September 14, 2000

Subject: Response to Comments and Revisions to the Five-Year Report
Medley Farm Site Remedial Action, Gaffney, South Carolina

FIGURE 5-4

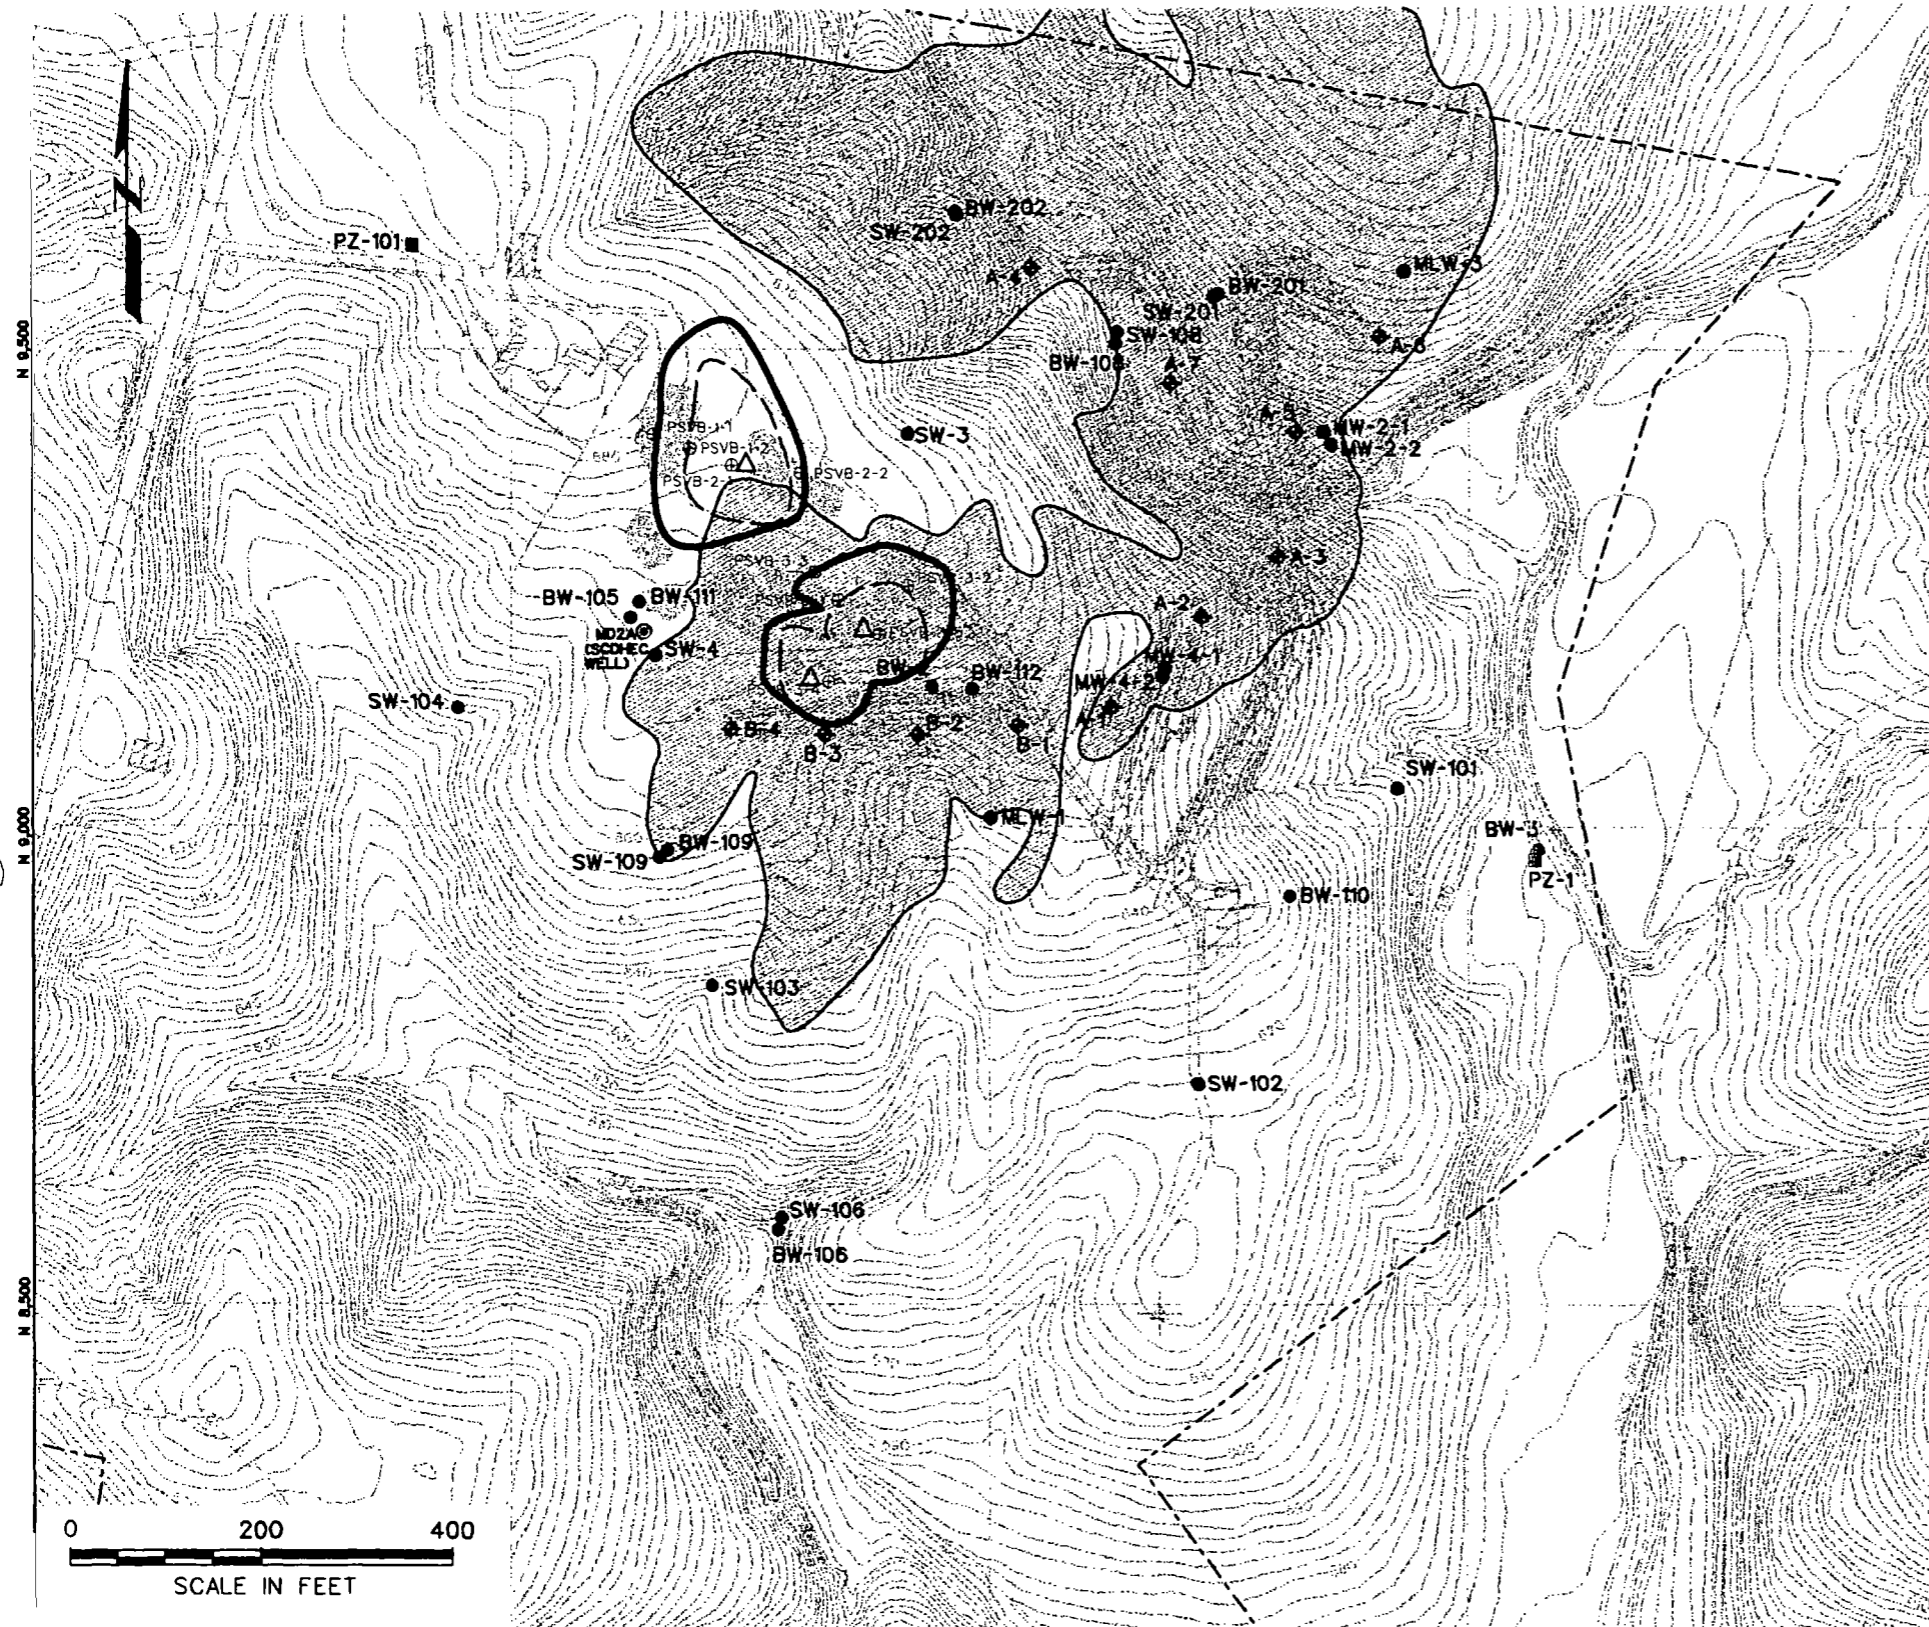
1. Replace Subsection 1.1 (page 1-1) with the enclosed page. The confirmation "by SC DHEC" was added for accuracy and the text regarding the use of the term "VOCs of concern" was clarified.
2. Replace Figure 5-4 (page 5-10) with the enclosed figure. The legend was corrected to show groundwater capture after one and two years of system operation.
3. Replace Subsection 6.1, Subsection 6.1.3 (pages 6-4 and 6-5) with the enclosed pages. Page 6-6 remains unchanged. An explanation was added to this section regarding soil vapor measurements attained to estimate projected VOC recovery rates.
4. Replace Subsection 7.1, second bullet (page 7-1) with the enclosed page. A statement was added to clarify reference to Table 3-4 showing overall decline in VOC mass recovered per volume of groundwater with a slight increase in 1999.
